SERVICE PARTS LIST

SPECIFY CATALOG NO. AND SERIAL NO. WHEN ORDERING PARTS		REVISED BULLETIN	DATE
7" GRINDER		54-38-1550	Aug. 2007
CATALOG NO.	6088-20	WIRING INSTRUCTION	
SERIAL NUMBER	994B	58-01-1370

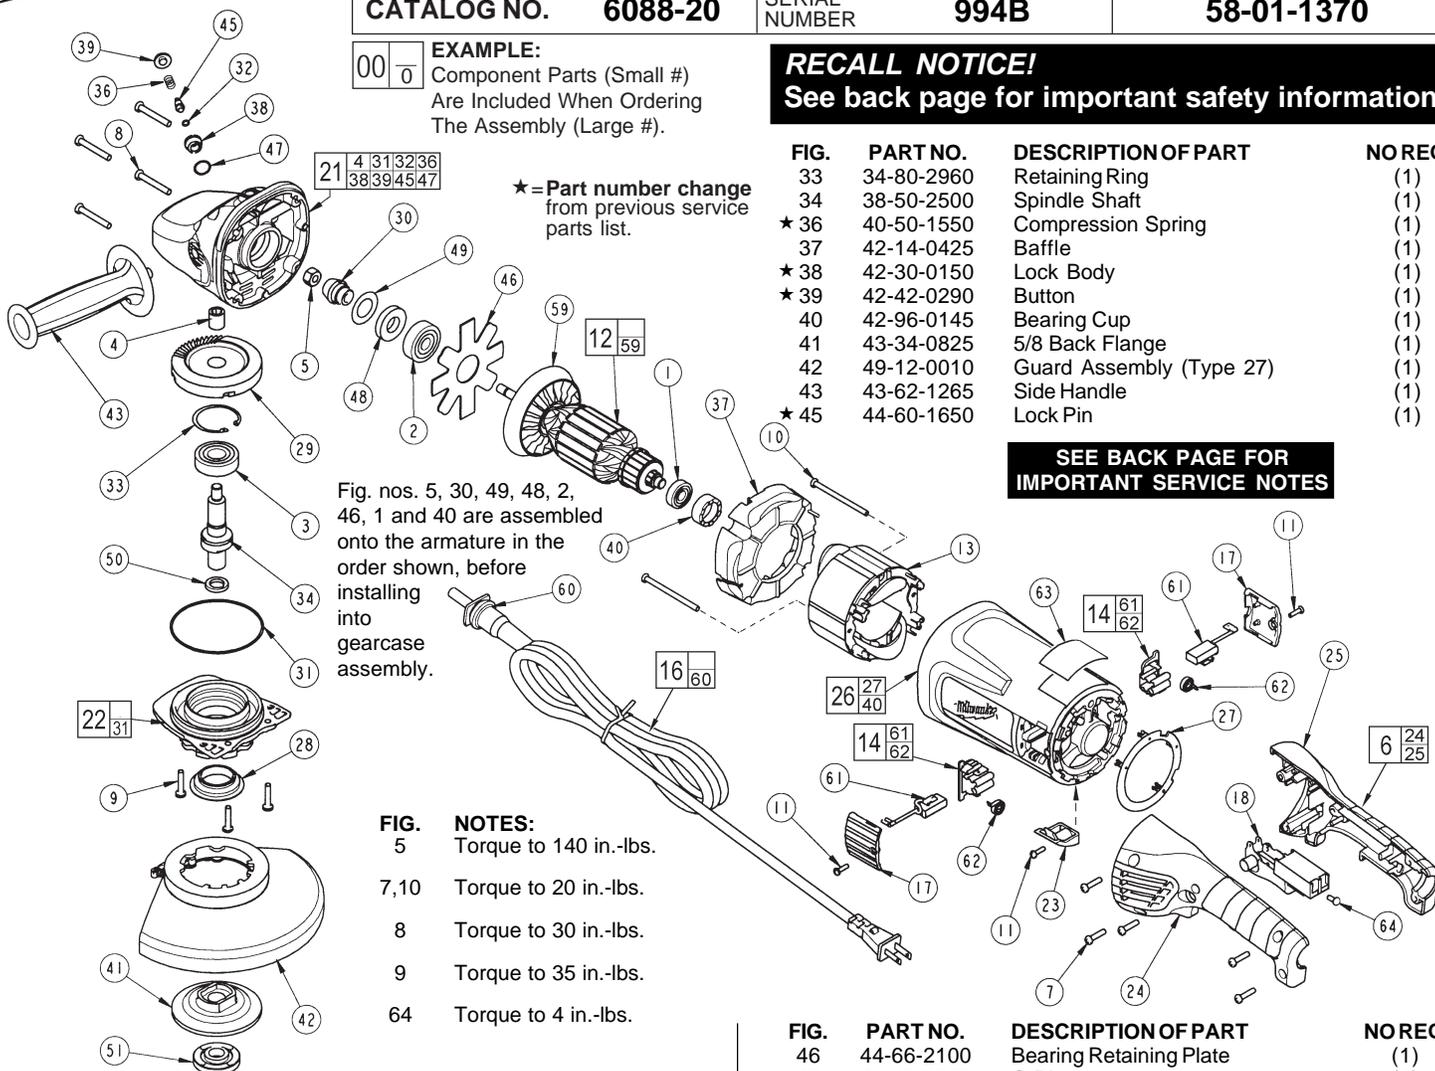
31-50-1752 Motor Housing Kit incorporates changes to the shielding of the armature pinion and commutator ball bearings along with the retaining of the pinion ball bearing into the gearcase assembly of 7"/ 9" 15Amp Sander / Grinders - 6080-20, 6081-20, 6082-20, 6086-20, 6088-20 and 6089-20.

Additionally, a change has been made to the motor housing and wiring of the tool. The ATF field coil is now 'hard-wired' with four [4] new leadwire assemblies, see **Wiring Instruction 58-01-1371**. Add 'X' Grease, 49-08-5000 to mag-mate field terminals as need.

Motor Housing Kit consist of:	Discarded Parts:	Model Affected
2ea 06-75-0510 1/4-20 Hex Screw* <i>item 15</i>		All
1ea 45-06-0830 Bearing Seal <i>item 19</i>		All
1ea 31-50-1785 Motor Housing <i>item 26</i>	31-50-1751 Motor Housing	All
1ea 31-53-0160 Plug**	31-53-0160 Plug*	All
1ea 31-55-0290 Dust Shield <i>item 35</i>		All
1ea 44-86-0040 Bearing Retainer ^A <i>item 46</i>	44-66-2100 Bearing Ret Plate	All
1ea 23-94-9300 LeadWire Assembly	23-94-2650 LeadWire Assy	All
1ea 23-94-9305 LeadWire Assembly	23-94-2655 LeadWire Assy	All
1ea 23-94-9310 LeadWire Assembly		All
1ea 23-94-9315 LeadWire Assembly		All
	42-96-0145 Bearing Cup	All

^A Service Note - 'check for slip fit' - mounting of 02-04-1680 Ball Bearing to the armature shaft may require removal of a 0.0001" - 0.0002" from the O.D. of the armature pinion end ball bearing journal - It is recommended to use emery cloth and armature lathe to lightly sand, for a few seconds, removing the material necessary for the pinion shaft to be a 'slip fit through the pinion ball bearing' as it is being held in place in the GearCase by the 44-86-0040 Bearing Retainer.

Stamp or etch an 'R' in the tool's nameplate next to the catalog number after installation of the 'current production' service replacement parts listed above.

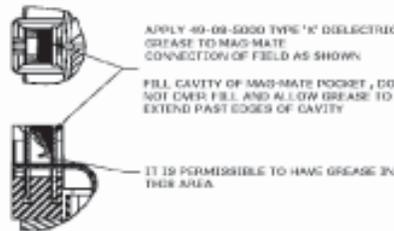
Milwaukee is providing a **no-charge** warranty service to all owners of **6086-20, 6088-20 and 6089-20 7"/9" Grinders**. We are taking this action because under certain circumstances the **'lock-on' Trigger Switch** can stick in the 'ON' position, which poses a risk of injury or property damage.

The original equipment switch (23-66-2710 / 23-66-2720) should be replaced with a new re-worked 23-66-2720. Reworked switches will have a white dot (indelible paint) applied to the location at the base of the switch (see illustration).

For operator safety a **6086-20, 6088-20 or 6089-20 7"/9" Grinder** within the listed serial number ranges should be returned to the nearest **factory** Service/Sales Support Branch or Milwaukee Authorized Service Station for a no-charge warranty replacement of the trigger switch.

If the nameplate has an **'X'** stamped into the tool's nameplate, next to the serial number, the tool has been repaired and the defective switch has already been replaced.
